15 April 2022

PROJECT: Hyla Crossing Pumped Stormwater Discharge Project, Issaquah, Washington

SUBJECT: Response to Comments

Hyla Crossing Pumped Stormwater Force Main Project Wetland E Rating - Cover Type Classifications Figure

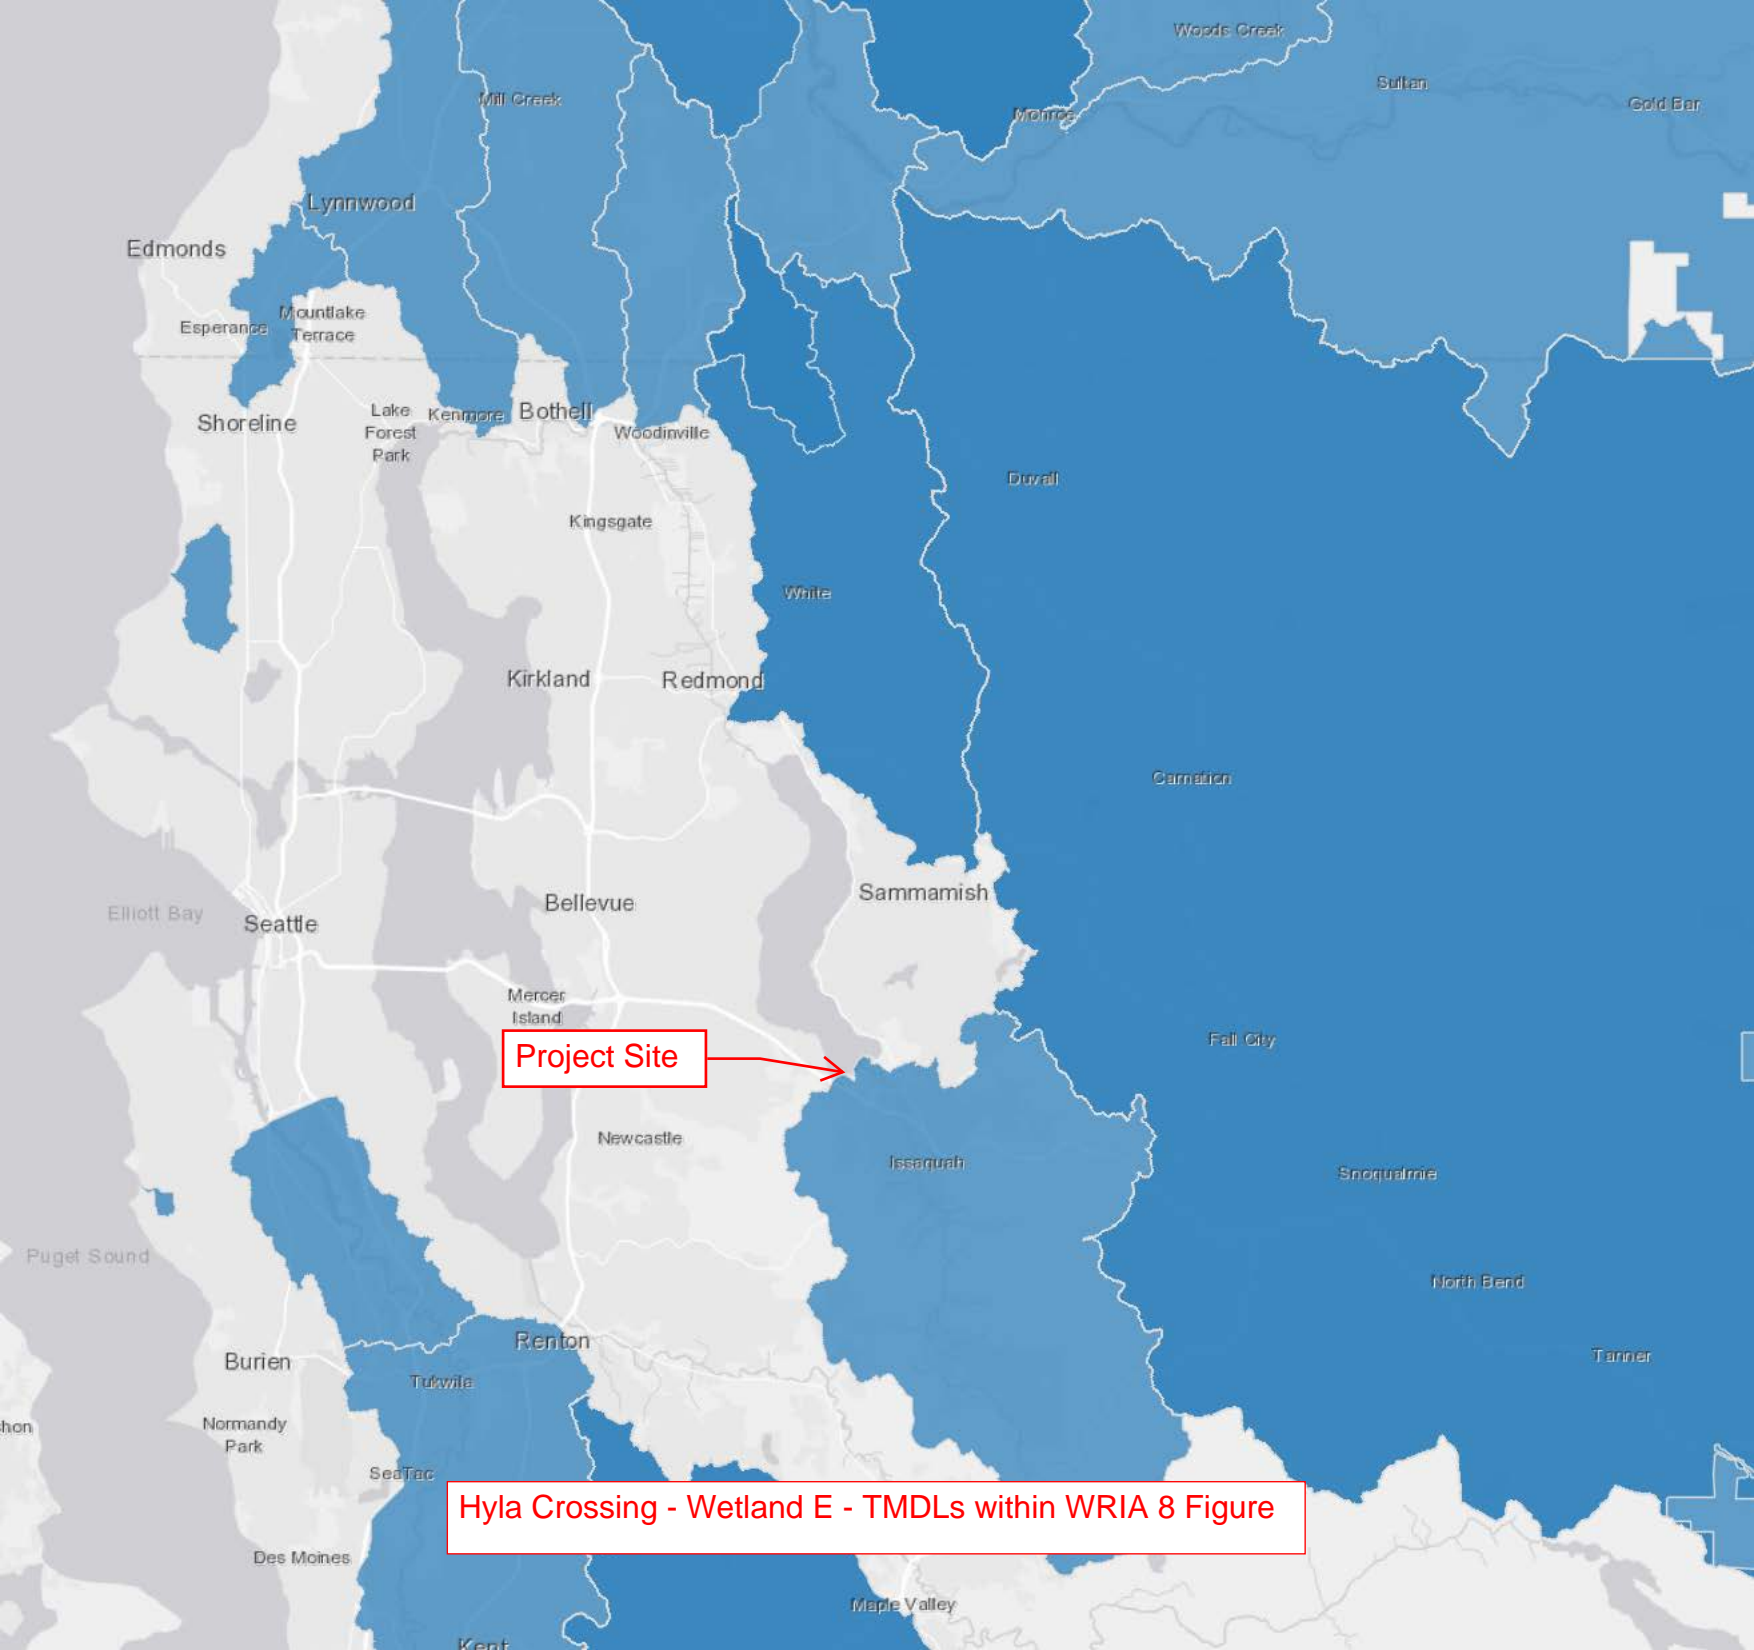
7. **Questions H2.1, H2.2, and H2.3 cannot be reviewed without the required rating form figure and area percentage calculations provided.**

See attached figure. The only effective change is that high intensity land use is not more than half of the polygon once the lake is accounted for appropriately.

SITE PLAN, IMPACTS & MITIGATION OVERVIEW PLAN

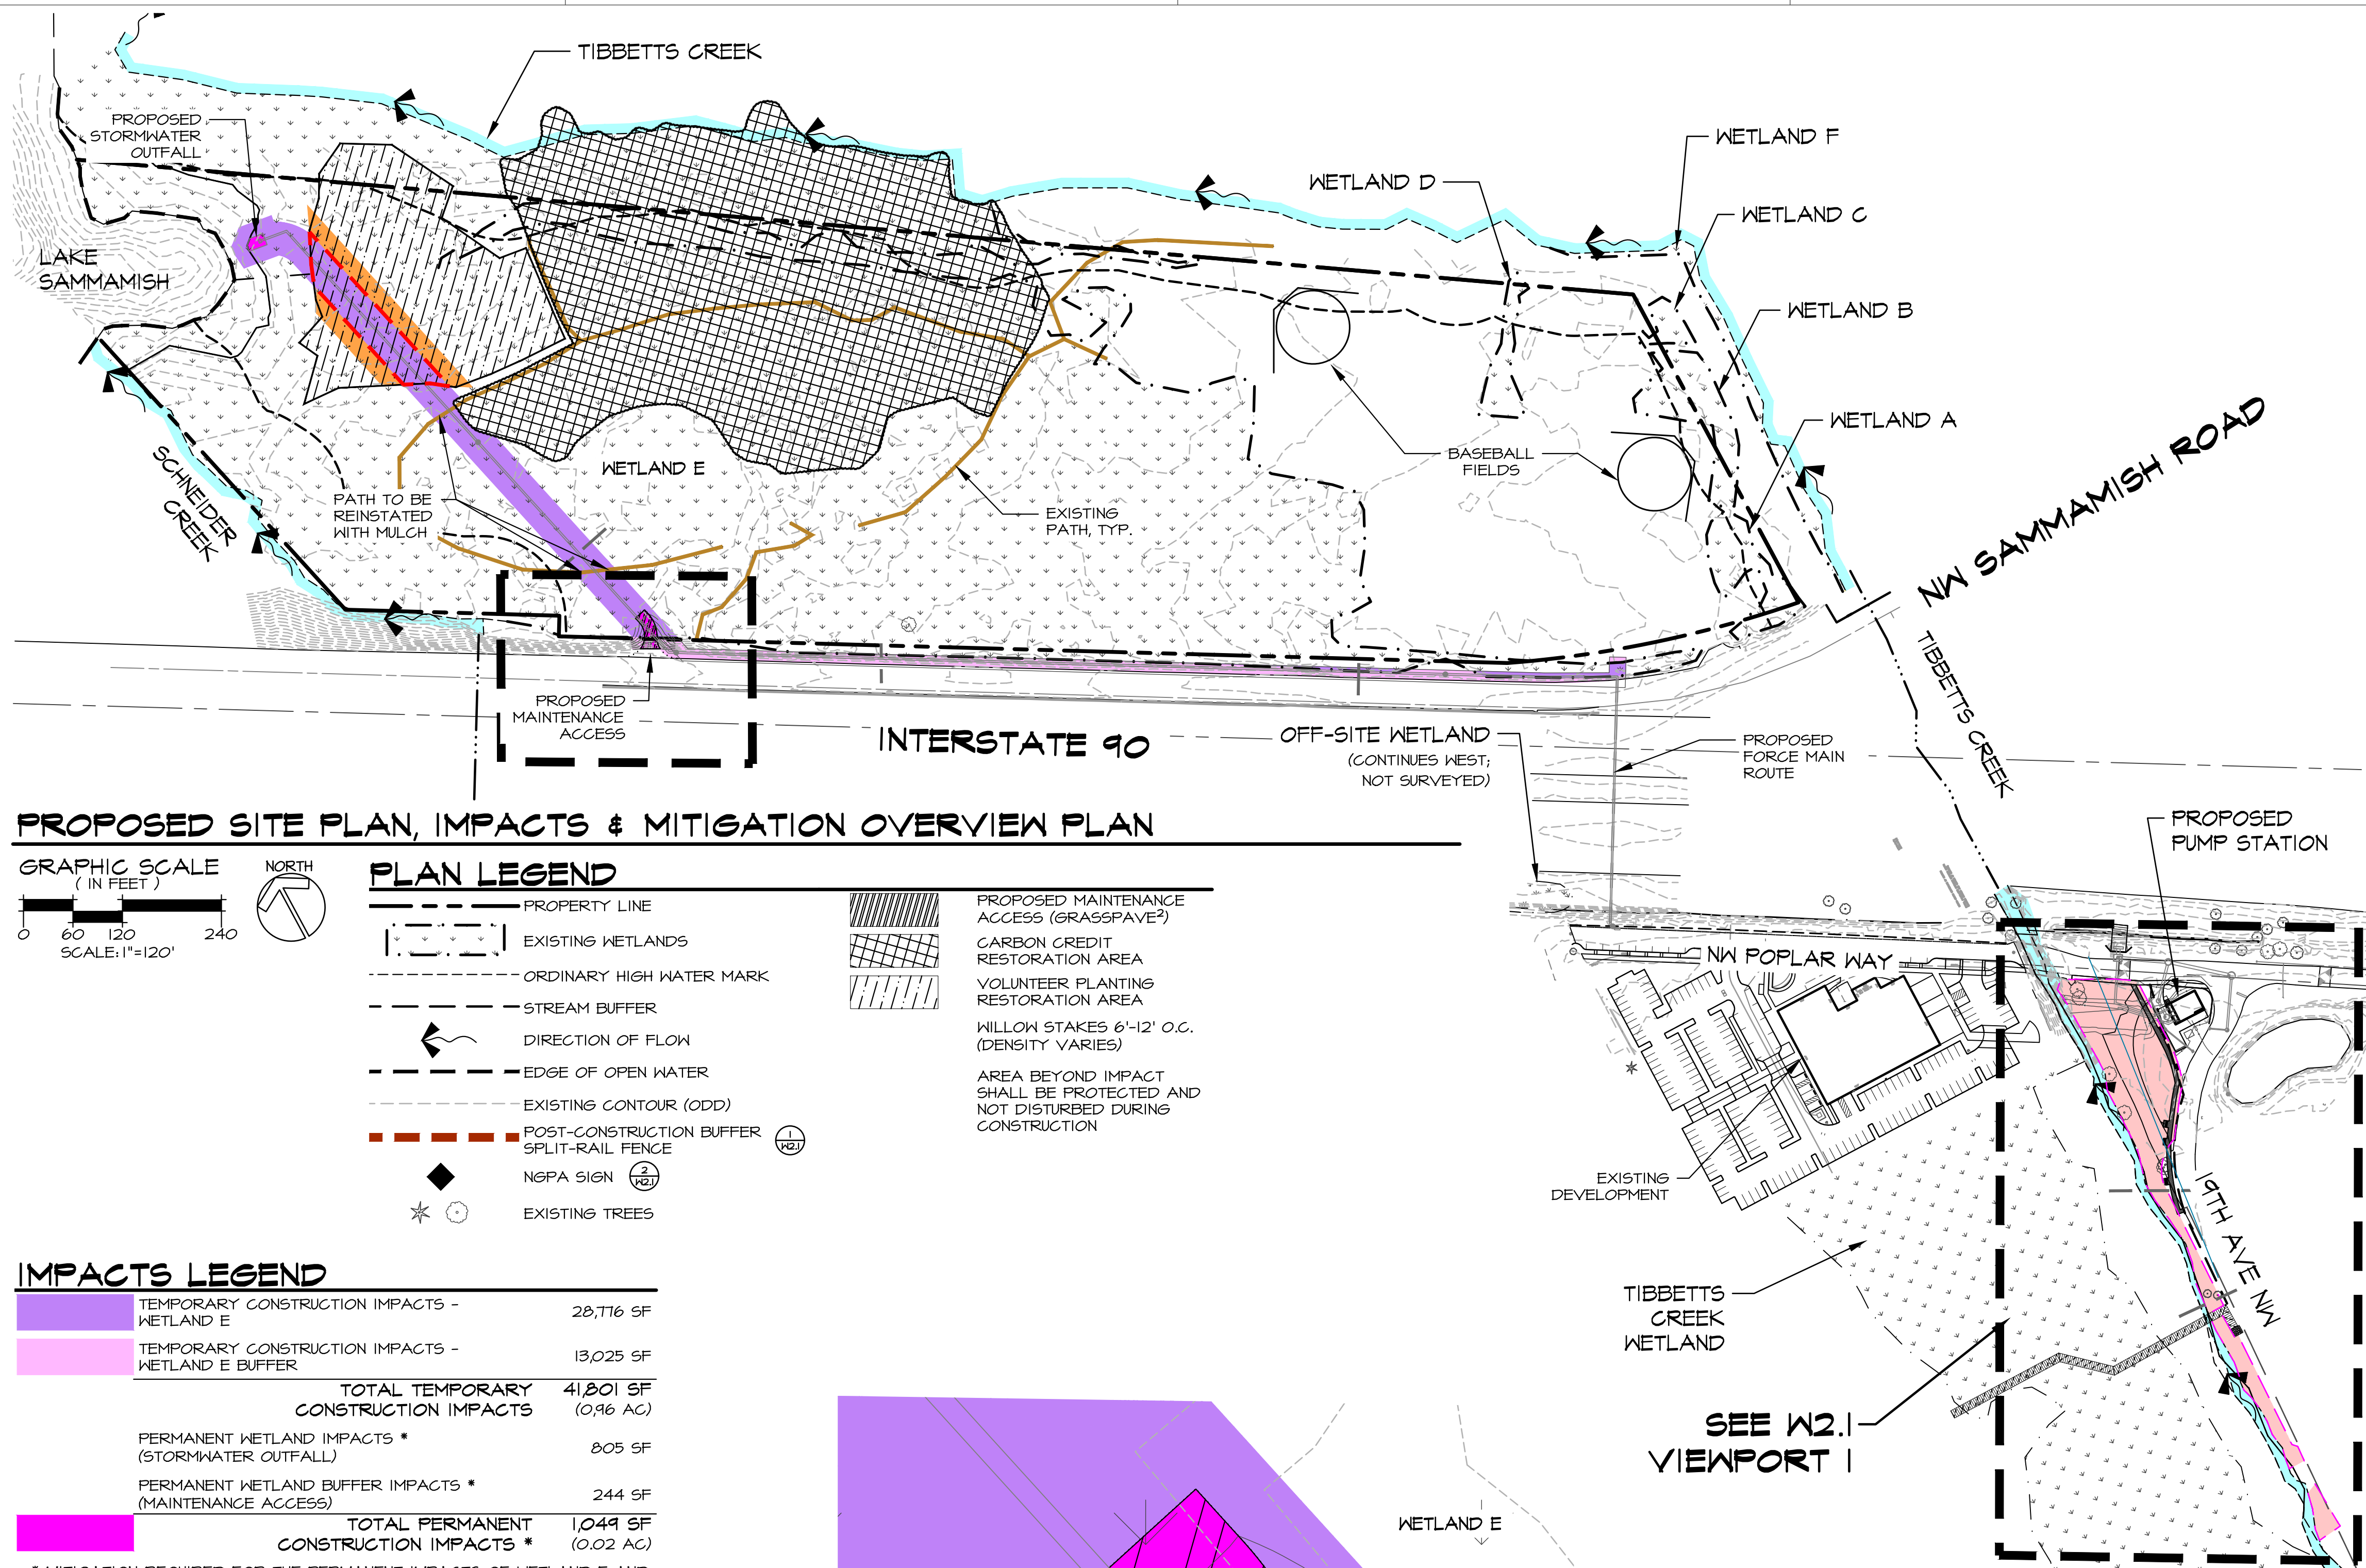
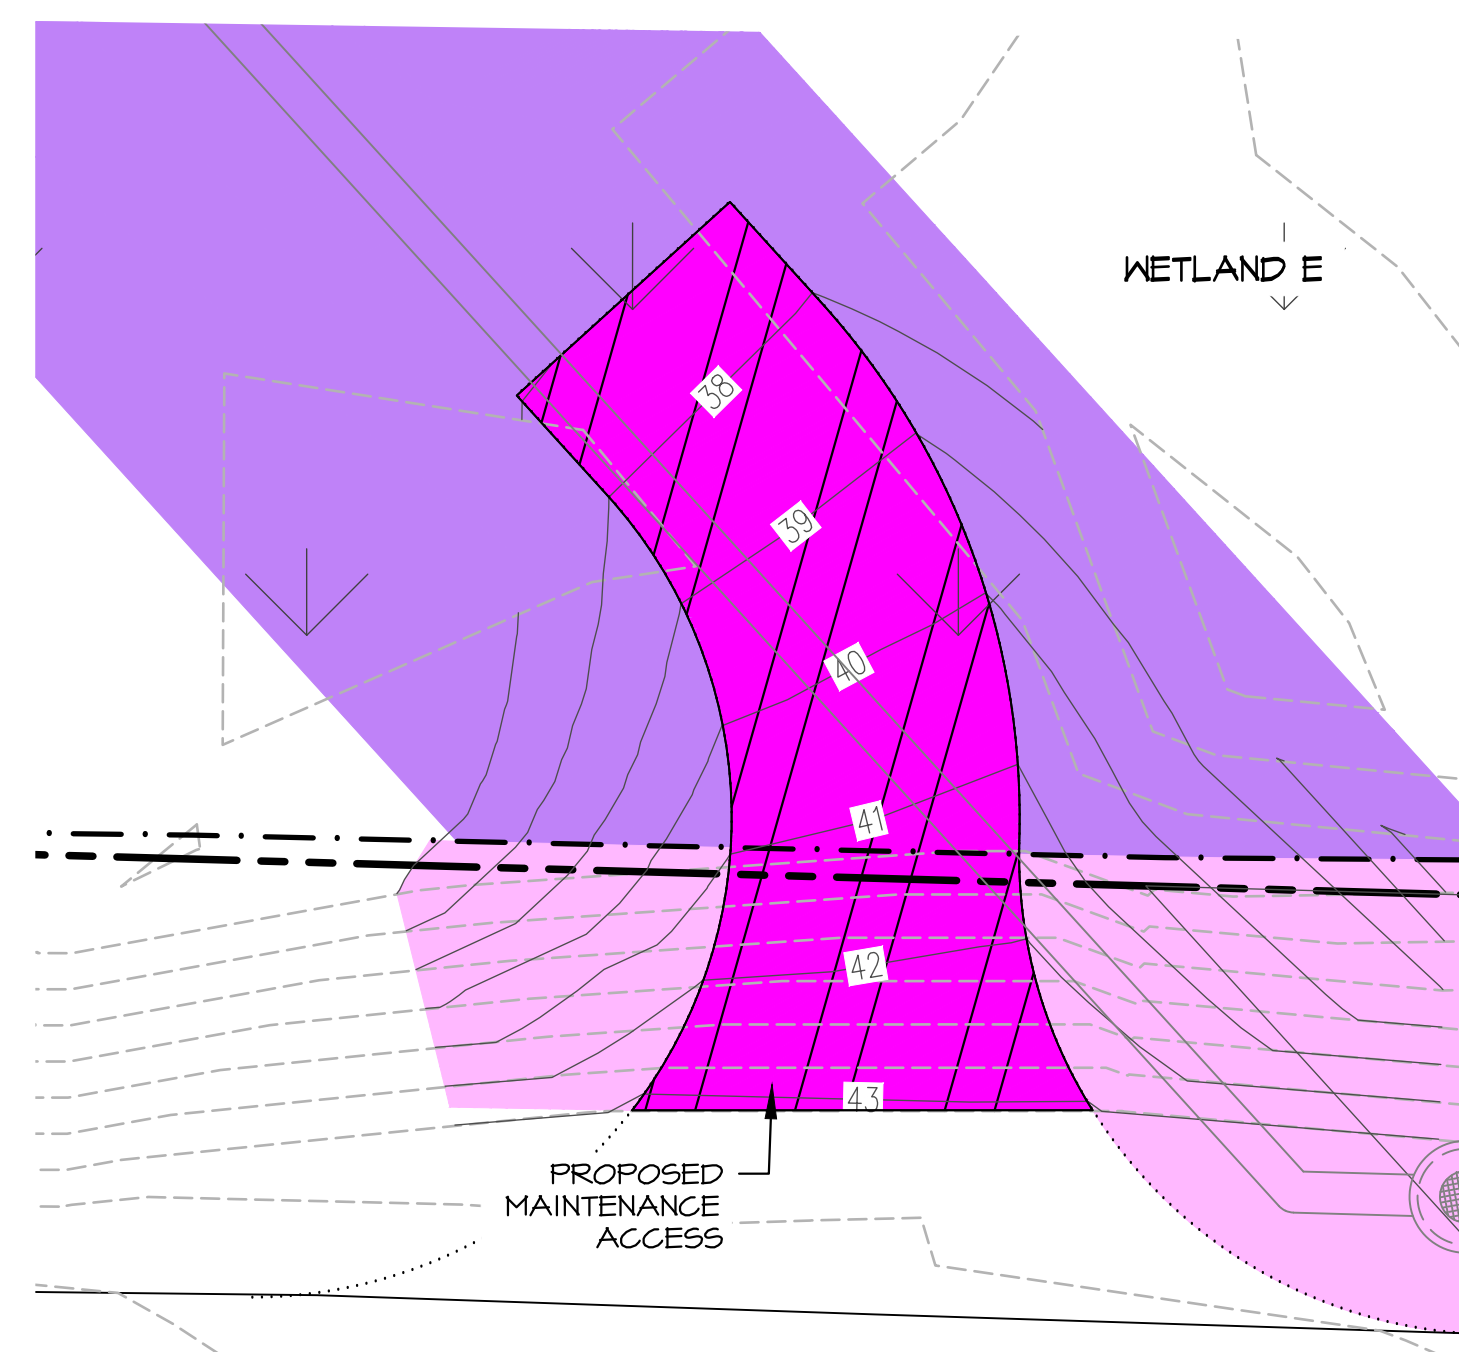
4. **Clarify the Plant Communities Legend on Sheet W3.3 to accurately depict where the Zone 4 willow stakes will be placed.**

- 2. **The "Plant Communities Legend" on Sheet W3.3 is confusing. The legend depicts the Zone 4 planting area as the entire existing volunteer restoration area and shows the Zone 1 planting area transecting the volunteer restoration area. The CAR and Sheet W2.0 clarify that the temporary impacts within existing volunteer restoration area, which has been planted with willow stakes, will be restored with willow stakes per the Zone 4 planting schedule. The Plant Communities Legend should be revised to clarify that the Zone 4 willow stakes will be placed in the temporary disturbance area, rather than the larger existing restoration area, similar to the depiction on Sheet W2.0.**

The proposed stormwater line transects the Volunteer Restoration area where willow stakes were previously planted by volunteers for the City at approximately 6' o.c. Note that Zone 4 is the Volunteer Restoration Area that occurs outside of the construction corridor. Those portions of the Volunteer Restoration Area that occur within the construction corridor have been included within Zone 1. The displaced willow stake replacement plantings will now be planted within Zone 4. The Volunteer Restoration Area (Zone 4) was found to have many large gaps that could benefit from additional (replacement) planting. The exact locations of these gaps were not surveyed as agreed by the City. A rough diagram was provided by the Parks Department to be used as a baseline in the attached Mitigation Plan and has been taken into account with the mitigation design. The 684 replacement willow stakes will be planted in the gaps within Zone 4 with the exact locations determined by a professional on site at the time of planting.

Note that Zone 4 is the Volunteer Restoration Area that occurs outside of the construction corridor. Those portions of the Volunteer Restoration Area that occur within the construction corridor have been included within Zone 1. The portion of Zone 4 reflected on the map has been reduced for clarity to show an area equal to the disturbed area of Volunteer Restoration Area by construction of the stormwater forcemain. The Zone 4 willow stakes will not be planted in the temporary disturbance area. These willow stakes will be used to infill the existing willow stakes where there are gaps in coverage, as outlined above in the response to Recommendations Question #4. The objective with this mitigation plan is to infill those sparse areas with the

estimated number of willows displaced by the construction area. Zone 1 plantings will include more than willows as a number of other shrub species have been included to add species diversity while also providing a path unobstructed by woody plant material for maintenance access to the outfall. The willows that will be included within the Zone 1 plantings are separate from those displaced willows to be planted in Zone 4.
